REMARKS

Applicant: Ta et al.
Application No.: 10/692,433

Fig. 3

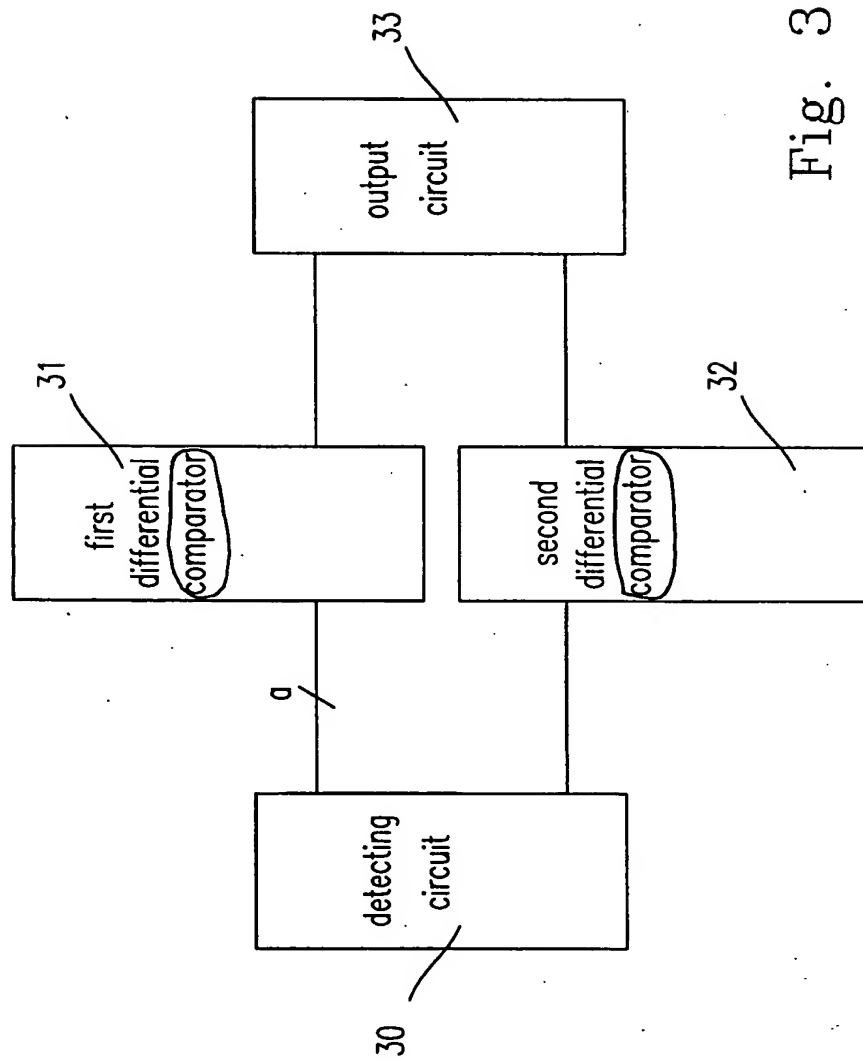
The “first differential comparator circuit” and “second differential comparator circuit” in Fig. 3 of the drawings of the present invention are replaced by “first differential comparator” and “second differential comparator” respectively according to the corresponding terms employed in the claims as originally filed.

Fig. 4

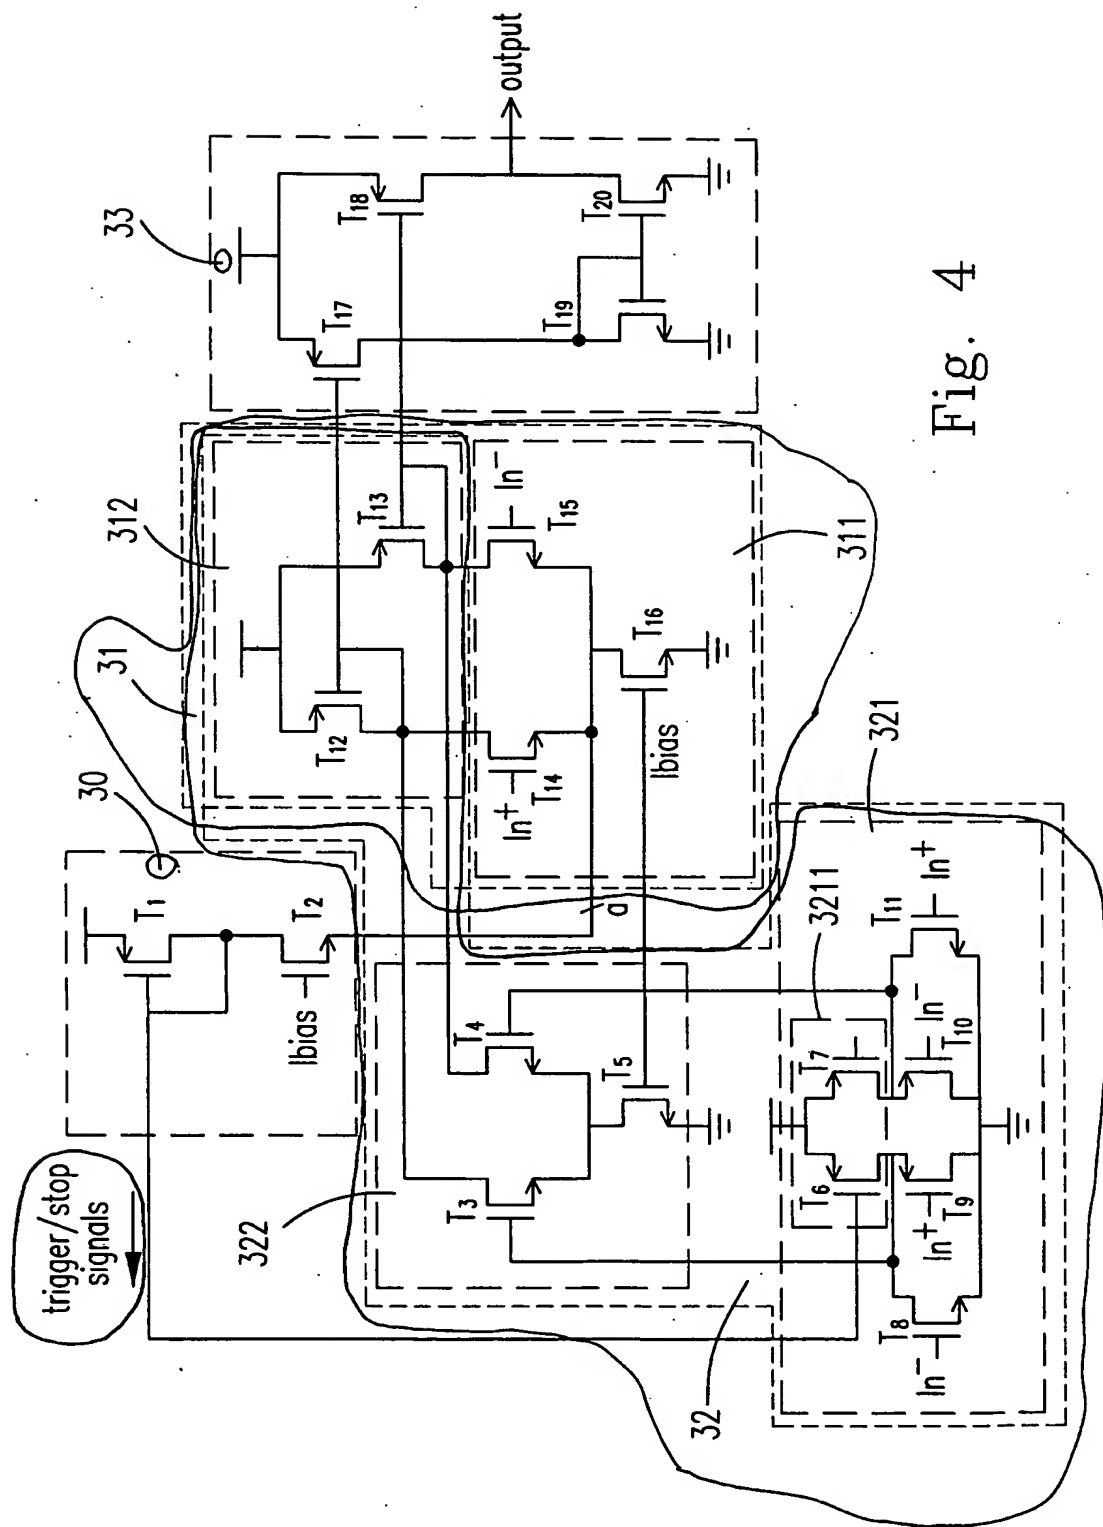
The Examiner requested that the trigger signal and the stop signal be shown in Fig. 4 of the present invention and that the Applicants explain how the voltage ranges are detected. Accordingly, the Applicants offer the following. The trigger signal is produced by the detecting circuit as disclosed in claims 1, 8, and 12 as originally filed, and the stop signal is also produced by the detecting circuit as described on paragraph [0035], line 5 of the specification as originally filed. Thus, the trigger/stop signals are marked at the output terminal of the detecting circuit as shown in Fig. 4. Furthermore, the operational status of the first operational receiving circuit (311) of the first differential comparator (31) is detected at the spot marked "a," as shown in Fig. 4 and described on paragraph [0031], lines 3-4 of the specification as originally filed. The operational principles regarding how the detecting circuit (30) can detect the status of the first differential receiving circuit (311), and how this "a trigger signal" can activate the second differential comparator (32) are further analyzed and described as follows.

All the transistors are labeled, and the numeral references of 31 and 32 as well as the trigger/stop signals are marked in Fig. 4 of the present invention to clarify the contents of the present invention as the esteemed Examiner has suggested.

Firstly, as shown in Fig. 4 of the present invention, one with the ordinary skill in the field would know that: (a) if $(ln+ \& ln-) > 2$, the first differential comparator (31) works ==> the voltage level of "a" is relatively high==>(the voltage

level of the output signal from the detecting circuit (30) to the pre-amplifier receiving circuit (321)) is relatively high (a stop signal) ==> the pre-amplifier receiving circuit (321) is off; and (b) if $(I_{n+} \& I_{n-}) < 2$, the first differential comparator (31) doesn't work ==> the voltage level of "a" is relatively low ==> (the voltage level of the output signal from the detecting circuit (30) to the pre-amplifier receiving circuit (321)) is relatively low (a trigger signal) ==> the pre-amplifier receiving circuit (321) is on. Secondly, "a stop signal" means that the voltage level of "a" is relatively high, and "a trigger signal" means that the voltage level of "a" is relatively low. Thirdly, from the above-mentioned description, the detecting circuit (30) can detect the status of the first differential receiving circuit (311) by sensing the voltage level of the marked place "a" to detect an input voltage of the detecting circuit (30) (an input signal of the detecting circuit (30)) as shown in Fig. 4 of the present invention.

Furthermore, as pointed out by the esteemed Examiner, the voltage level of the trigger/stop signals = $(VDD - \text{transistor-connected diode drop})$, one with the ordinary skill in the field would know that when the voltage level of "a" (as shown in Fig. 4 of the present invention) is relatively low, the voltage drop of the transistor-connected transistor T1 is relatively high, and thus the level of the output of the detecting circuit (30) ($=VDD - \text{voltage drop of T1}$) is relatively low (a trigger signal) firstly. Secondly, when the voltage level of "a" is relatively high, the

voltage drop of the transistor-connected transistor T1 is relatively low, and thus the level of the output of the detecting circuit (30) ($=V_{DD}$ - voltage drop of T1) is relatively high (a stop signal) secondly. Thus, when the voltage level of the output signal of the detecting circuit (30) is lower enough (a trigger signal), the transistor T6 of the level shift circuit (3211) would be turned on instead of always being turned off by a relatively higher positive voltage as considered by the esteemed Examiner. For the reasons set forth above, Applicants request withdrawal of the objections as well as the rejection of claim 1 under 35 U.S.C. § 112, first paragraph.
